Application Ref: H03-0681-21

Proposal: **Details of external materials, landscaping and surface water drainage (Conditions 3, 5 & 8 of H03-1153-18)**

Location: **Poplar Farm Estates Ltd, Main Road, Deeping St Nicholas, PE11 3DJ**

Title
Proposed Drainage & External Works Details

Typical Permeable Private Roadway Detail

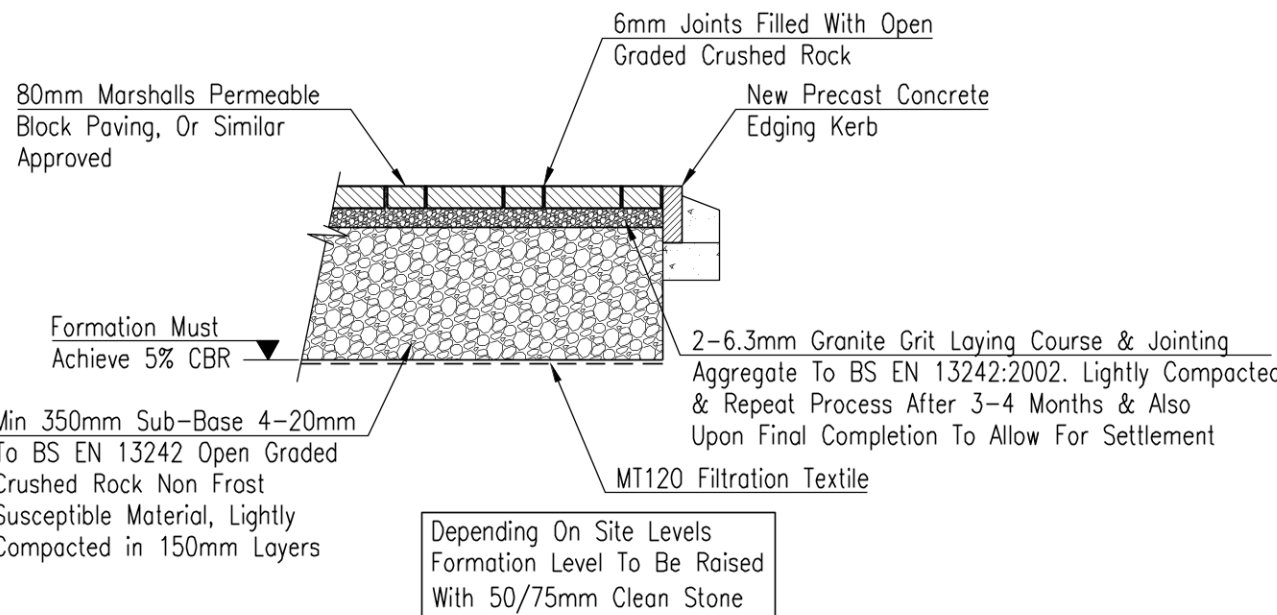
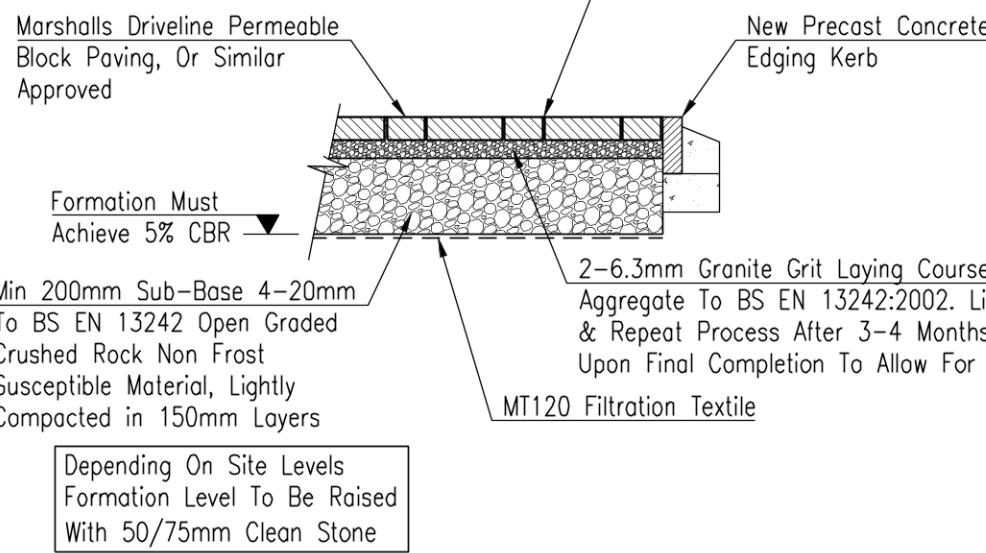
To this end, it is recommended that the Applicants or their Drainage Consultant be asked to provide evidence that the soils of the Application site have been proven by prescribed testing processes to be suitable to allow infiltration from the proposed permeably paved private roadway and drives, that the thickness of the stone sub-base of the private roadway and drives has been designed to provide the required capacity for the storage of storm water and that the specification of the stone sub-base for the private roadway and drives provides the required voids for the storage of stormwater - the description of 'Open Graded Crushed Rock Non-frost Susceptible Material' does not provide sufficient confidence that the required material would be laid by the appointed contractor.

Please find attached the updated civil engineer drawings with further information on the private roadway and drives sub-base (see ref. 30320-02B) and infiltration tests as requested.

Rev	Date	Remarks
B	24.09.21	Sub-Base Notes Amended Following LLFA Comments.
A	06.09.21	Addition of roadway detail.
